P96-002 - 150/180 HARRIS AVENUE: REVIEW & COMMENT

BACKGROUND INFORMATION: The purpose of this staff report is for review & comment of two proposed warehouse buildings totalling 50,000 square feet (Building A is 20,000 sqft, Building B is 30,000 sqft). The subject site is located within the Norwood Tech Planned Unit Development. As such, any building requires a Special Permit approval from the Planning Commission. The applicant has requested a preliminary review of the project relative to its site design and building orientation.

SITE PLAN
FOR HCP PATH OF TRAVEL REQUIREMENTS SEE NOTE "B" SHEET "A"

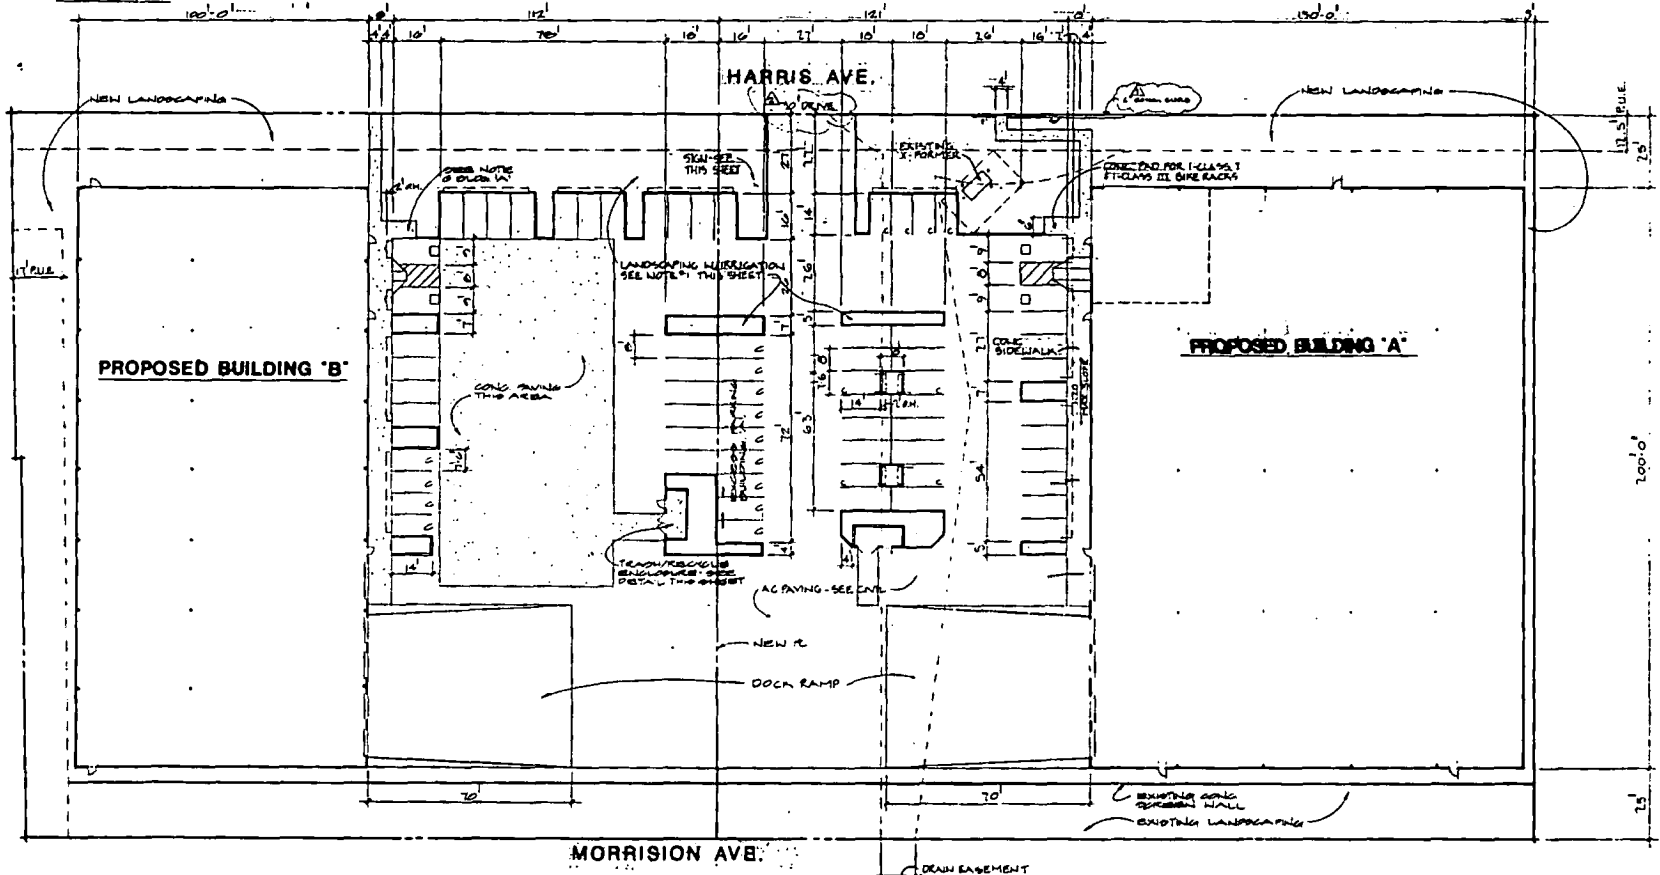
1. **Landscaping:** The PUD Guidelines require an 8' masonry wall and 25' of landscaping along the south elevation. The wall and basic landscaping are already in place. However, between the existing trees, the walls are bare. Staff may recommend that additional landscaping (e.g., vines or rose bushes) be planted between the trees. The PUD Guidelines require 5' landscaping at the eastern & western boundaries. At the western edge of the property, 17' is provided; at the eastern edge of the property, 5' is provided.

2. **Parking/Circulation:** A total of 57 parking spaces are required; 66 spaces are provided. Ingress/egress to the site is provided from Harris Avenue, which is consistent with the intent of the PUD to minimize impact on the residential uses south of Morrison Avenue. The driveway and parking layout is similar to that of other buildings in the PUD and similar to that approved in 1986 for this site.

ELEVATIONS
BUILDING 'A'

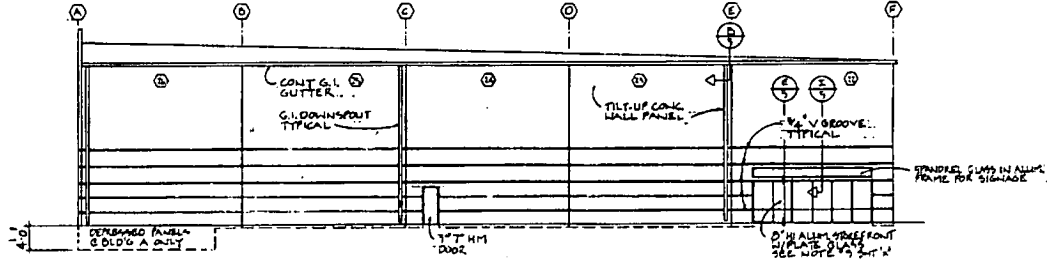
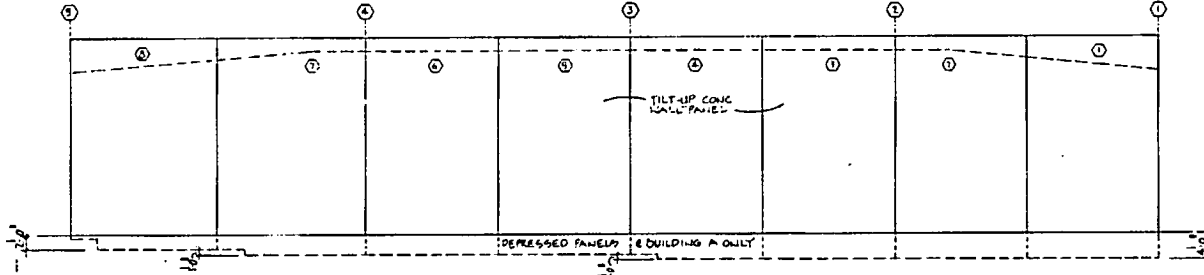
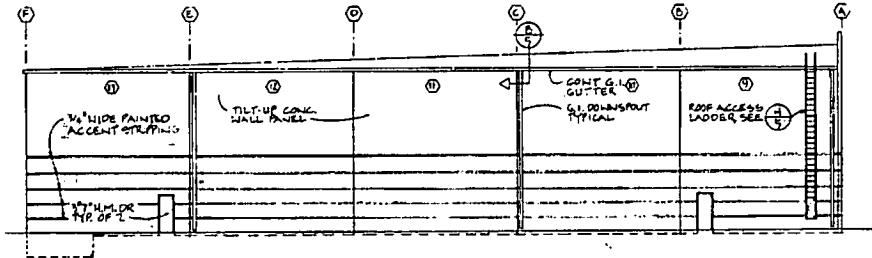
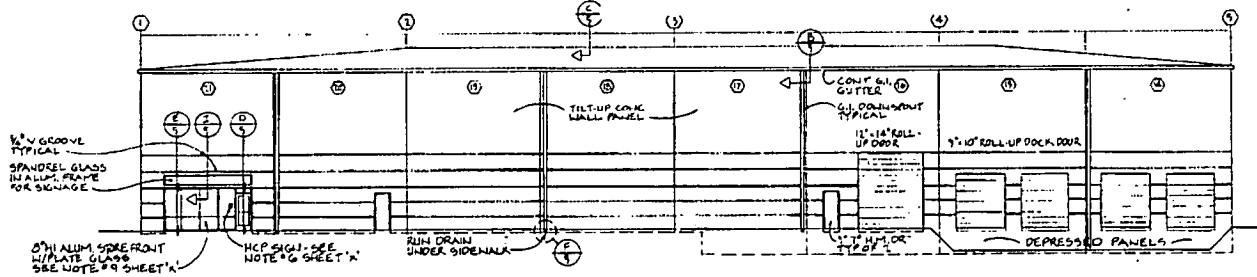
1. **Materials:** The proposed building materials are concrete tilt-up construction with a sloping roof with built-up mineral cap sheet roofing material. A parapet (extension of the exterior wall) extends approximately 2½ feet above the roofline (required by Fire Safety Code).

2. **Signage:** No signage plan has been submitted as part of this application. Signage shall meet the PUD Guidelines.
3. **Color:** The applicant proposes several reveal lines, although a color palette has not yet been determined. Staff would support either multiple bands or variations in a single wide band. The proposal is consistent with the quality of other buildings in the PUD.

4. **Height & Scale:** The building height is 30', except that the roofs are sloped with an additional 4' on the outer western and eastern elevations of the subject site. These additional heights are relatively minor and minimally impact the residential uses to the south. The PUD Guidelines would require amendment to allow this additional height for the portion of the "plateline" (top of roof joist). The standard height limit for commercial buildings adjacent to residential is 35'.
